ASSESSMENT REPORT

**Global Switch Data Centre
273 Pyrmont Street, ULTIMO
MP 08_0222 MOD 6**

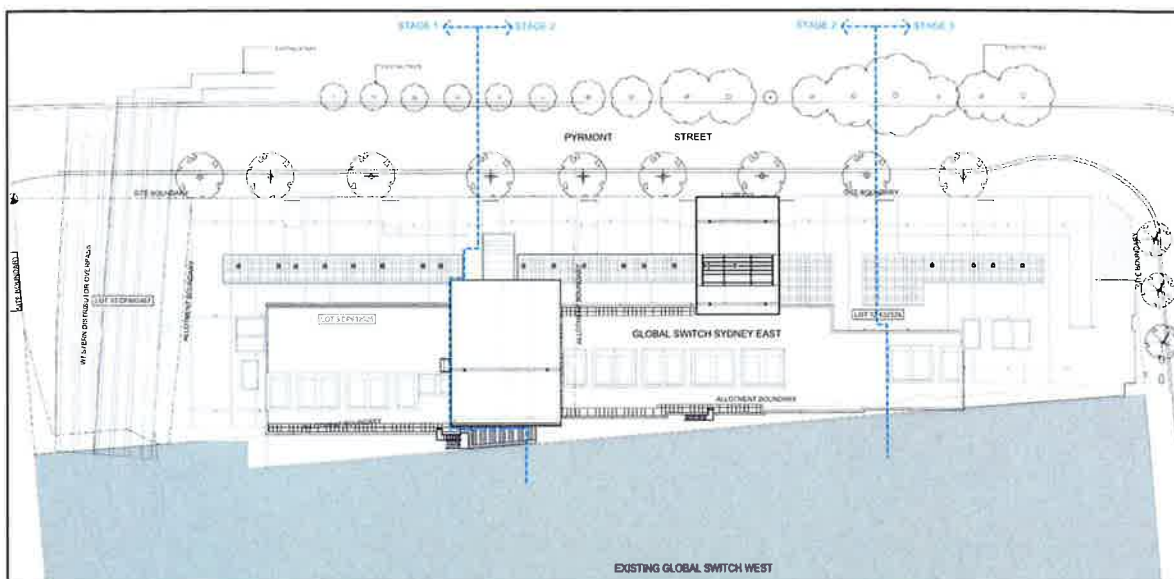
On 16 June 2015, the Proponent lodged a section 75W modification application (MP 08_222 MOD 6) seeking approval for internal and external modifications across Stages 2 and 3 of the approved building (**Figure 2**) as follows:

- deletion of the Pyrmont Street building entry and associated façade changes;
- lighting concept plan for the building elevation at ground level;
- minor internal amendments across Stage 2 and 3;
- reduction off gross floor area (GFA) by 319m²;
- reduction and reconfiguration of the Stage 2 basement footprint; and
- deletion of the paved terrace area associated with the breakout area at Level 7.
